**Proposed Development: Approval of reserved matters for the appearance, landscaping, layout and scale for the erection of 3 No. dwellings pursuant to planning application 10/20/0806**

**Site Address: Land adjacent 18 Northumberland Close, Darwen, BB3 2TN**

## **1.0 SUMMARY OF RECOMMENDATION**

Figure Three – Proposed Front Elevations and Materials Palette

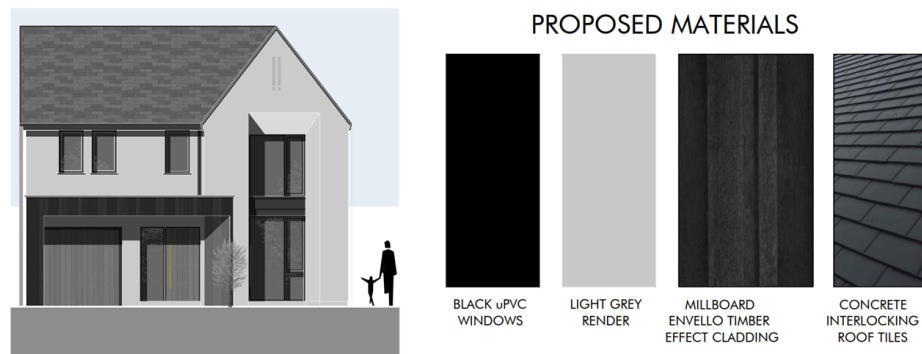
3.2.2 The proposed dwellings would be two-stories in height. They would have maximum lengths of 11m, widths of 9m and dual-pitched roofs up to 7.7m in height. A garage, kitchen and living areas would be formed on the ground floor with 4 bedrooms and bathrooms on the first floor. Pale grey render, timber effect cladding and grey concrete tiles would be used to externally finish the dwellings and they would be fitted with black uPVC doors and windows.

- 4.3.1 The proposed dwellings would be arranged staggering a small cul-de-sac. They would be built in a contemporary style when compared with the surrounding dwellings owing to the use of modern construction materials/colour schemes, recessed window panels and flat-roofed canopy features.
- 4.3.2 Whilst some of those features would not align with the defining architectural characteristics of the local area, mature planting on the south boundary, which would all be retained, would result in the proposed dwellings largely being viewed separately to the streetscene of the surrounding residential cul-de-sacs. New planting on the northwest boundary would also assist with that outcome.

- 5.2 No above ground works shall commence site unless and until, details confirming the exact type of all the external materials to be used in the construction of the development hereby approved, together with details confirming the colours and finishes of any windows and doors to be installed, have first been submitted to and approved in writing by the Local Planning Authority. The development shall thereafter proceed in strict accordance with the approved materials and details.

Figure Six – Proposed Landscaping Scheme (amended)

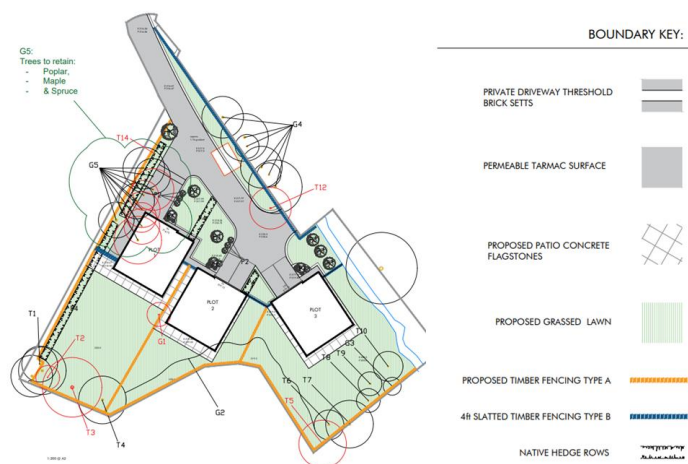
- 4.4.1 A comprehensive Landscaping Scheme has been submitted in support of the development, which is shown below in Figure Six. Concerns have been raised in public comments regarding the presence of a number of mature trees within the site and the loss of habitat. Reservations were identified by the BwD Arboricultural Advisor regarding the scheme initially submitted. An amended

- 4.4.2 The amended scheme involves the retention of a larger number of trees, which accords with the recommendations set out in the submitted Arboricultural Report and Impact Statement. A condition is recommended to ensure adequate tree protection measures are provided during the construction phase of the development in order to minimise damage to retained trees during that phase.

- 4.4.3 Supplementary soft landscaping would be provided around the site as part of communal areas and gardens. The planting mix would comprise of ornamental specimens alongside a new deciduous hedgerow along the northwest site boundary. Hard landscaping would be limited to permeable tarmac for the access road and driveways with concrete flagstones used for the walkways and patios. Appropriate boundary fencing of two styles is also proposed. A condition is recommended to ensure the fencing is provided in support of the development to minimise overlooking for the immediate neighbours and between the adjacent plots.

- 7.1 BwD Arboricultural Advisor – The landscaping proposals have not been integrated with the recommended works in the Arboricultural Report & Impact Statement. For instance, planting proposals would conflict with proposed retentions of Larch trees in G4 and trees G5 of the survey data recommendations. It is important to establish those trees to be retained with the integration of landscape planting proposals. There is a lack of tree and shrub planting numbers, sizes, planting specifications. Also there is no landscape maintenance programme.

(Update) I have inspected the site and considered the landscape proposals including the revised, amended landscape plan. The revised, amended landscape plan allows for the retention of three trees on the boundary with plot 1. The site has a good structure of semi-mature trees which provide good screening and valuable amenity along the boundaries. The proposed planting will provide suitable landscape structure for the housing layout. The landscape maintenance program document is suitable and the implementation of the specified maintenance should ensure establishment of planting material. To conclude, the revised, amended landscape plan and landscape maintenance program documents are suitable to approve.

- 4.4.4 Conclusively, the amended landscaping proposals would be acceptable in the context of this development and site. A condition is recommended to ensure the development is landscaped in accordance with the submitted details. A further condition is recommended to ensure the landscaping scheme is maintained in accordance the submitted programme. Subject to compliance with those conditions, the proposed development would be acceptable with reference to landscaping.

Figure Seven – Plot 1 and 19 Westmoreland Close

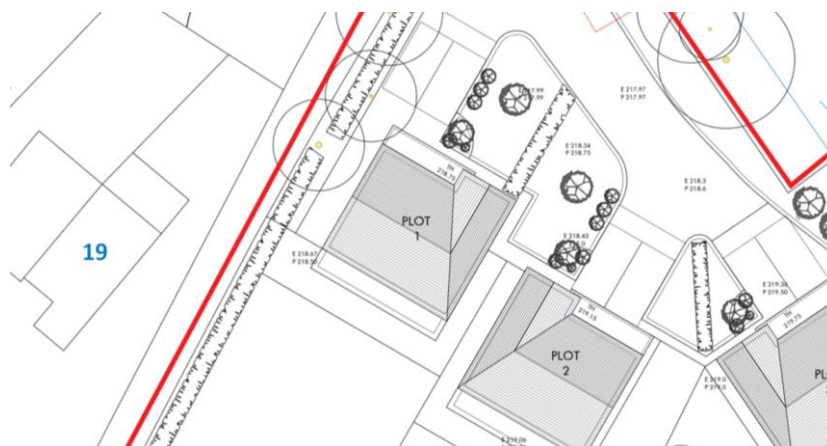
- 4.5.3 An amended layout has been submitted during the course of the application and Plot 1 has been shifted further away from a rear conservatory at 19 Westmorland Close to reduce its dominance. The levels of separation involved would ensure the proposed dwellings do not appear overbearing, or cause any unacceptable losses of light for the immediate neighbours.

- 4.5.4 The same outcome is applicable to privacy distances and main habitable room windows are limited to the front and rear elevations alone. A condition is recommended to ensure the side windows in Plots 1 and 2 are obscurely glazed so as to minimise overlooking. The previously recommended condition removing certain permitted development rights would also ensure the amenities of neighbours are adequately safeguarded from future development.

- 5.8 The side windows to be installed within Plots 1 and 2 hereby approved shall be fitted with obscured glazing with a minimum level of obscurity of Level 3. Any replacement glazing shall be of an equal degree of obscurity and the effects of obscurity must not be negated by way of opening.

Figure Nine – Retained Walkway

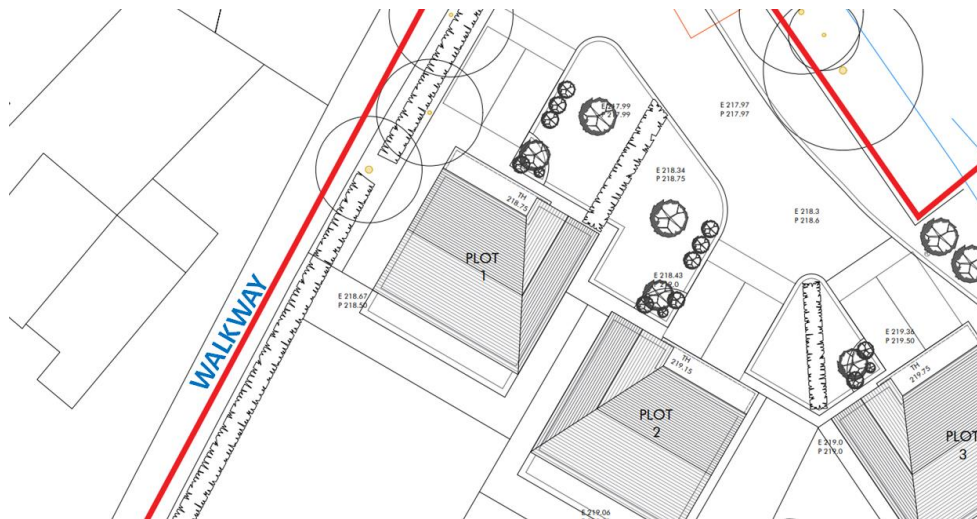
- 4.7.3 The PROW that runs to the northeast of the site would not be effected by the development. The informal walkway that connects Northumberland Close with Cranberry Lane would also not be effected, as shown below in Figure Nine. Furthermore, a development of this size would not degrade the surface of public roads to a level that would warrant additional controls in the way of condition surveys and subsequent repair works.
